NUEVA AZALEA POWER PLANT PROJECT DATA REQUESTS

This second set of data requests (#87-135) is being made in the areas of air quality, cultural resources, land use, noise, socioeconomics, soil & water resources and traffic & transportation. In the first set of requests, three requests were inadvertently misnumbered. This round starts with the correct number. Written responses to the enclosed data requests are due to the Energy Commission staff on or before November 27, 2000, or at such later date as may be mutually agreed. Supplemental information for the first set of requests that had inadequate responses is due no later than November 1, 2000.

**NUEVA AZALEA PROJECT
DATA REQUESTS
(00-AFC-3)**

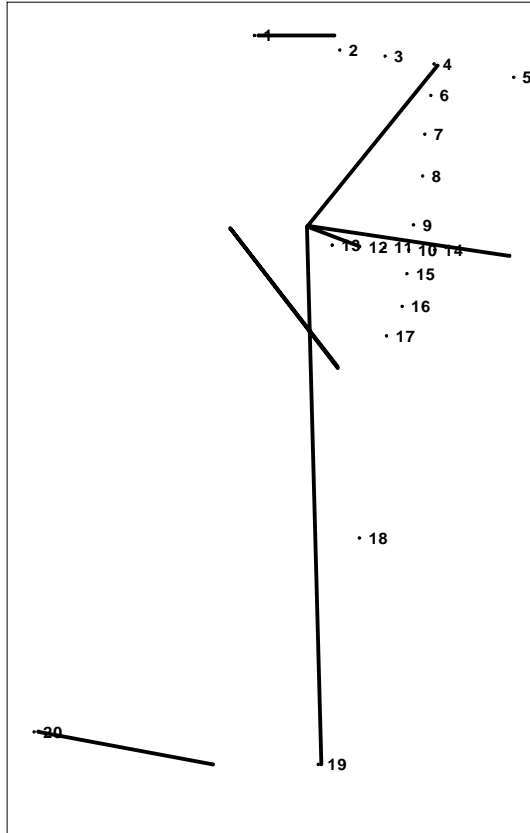
The following figure presents the line sources and the location of the receptors used with the CALINE model to estimate the impacts due to the heavy trucks and also due to the J.B Hunt truck depot emissions. It is difficult to understand the rationale used in the selection of the receptor and the representation of the nearby roads.

Please prepare a figure such as the above figure with the names of the streets and roads that each line is supposed to represent. Please also draw the boundaries of the J.B. Hunt truck depot site and clearly identify the location of the receptor that represents the 1999 air quality station. Please also include a scale to this figure.
